Subject: Response to DMS comments on the Year 5 Monitoring Report Draft review for the Logan Creek Stream Restoration Project; Savannah River Basin - CU# 03060101; Jackson County, North Carolina; NCDMS Project # 92515; Contract No. D06046-A

Logan Creek Stream Restoration Project Year 5 Monitoring Report

**Jackson County, North Carolina
NCDMS Project ID Number – 92515**

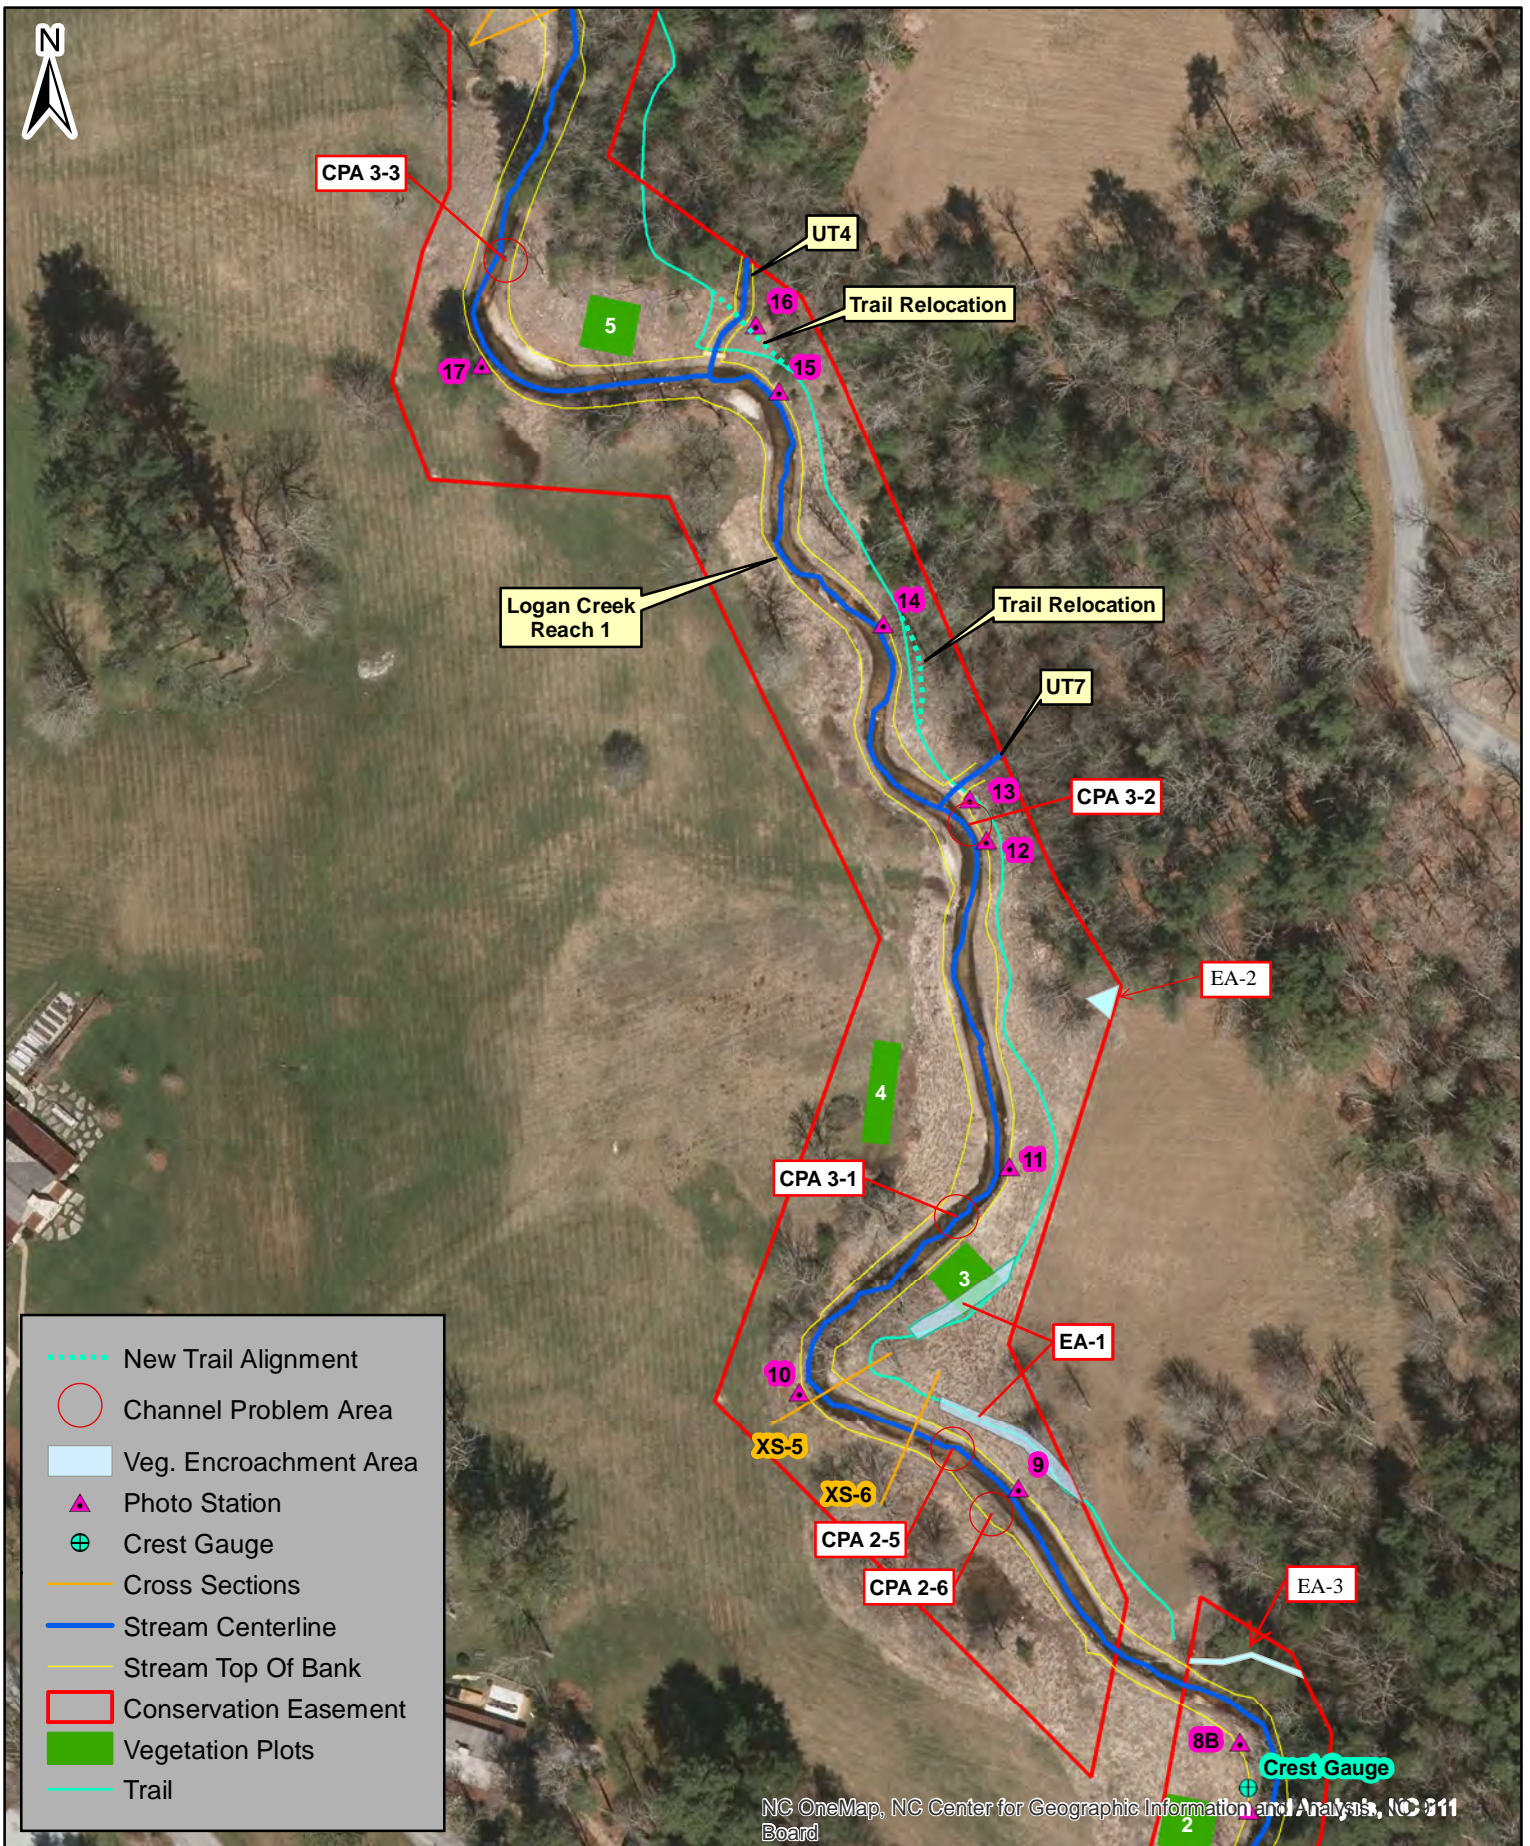
- **Section 2.1 - Vegetation Assessment:** Please QA/QC the third paragraph. Based on Figure 2B, “Stream Relocation” should be updated to “New Trail Alignment”. Please also report the trail’s approximate average distance from Logan Creek and its approximate minimum distance from Logan Creek. Please also report the trail’s approximate width.
It appears that the reference should have been to the fourth paragraph where the trail was discussed. The wording has been corrected and trail measurements have been added to the discussion.
